**5th July 2022**

Notification of Change

CHDX8-225
CHDX8-225C
CHDX8-325
CHDX8-325C

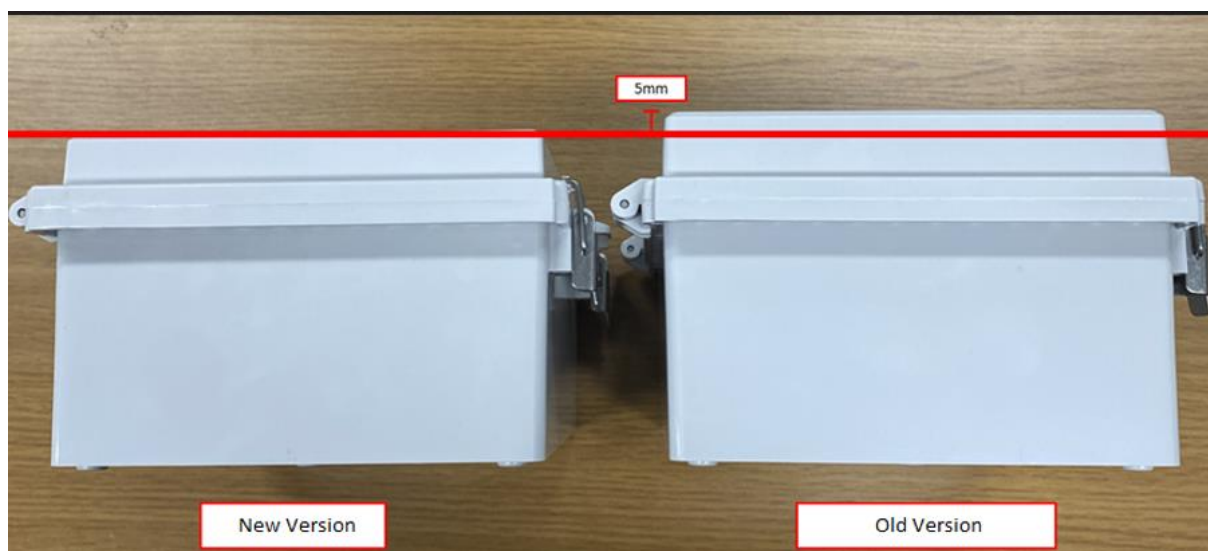
Effects of change: The lid on the new version is 5mm slimmer than previously, result in a total enclosure height of 105mm

The external edges of the enclosure are now more angular/square.

The locking flange point has moved to a central location and the hole is smaller than before.

Also, the roof lip that prevents moisture from getting in the seal has been extended further to the ends of the enclosure and the latches/hinges have moved a bit closer to the corners.
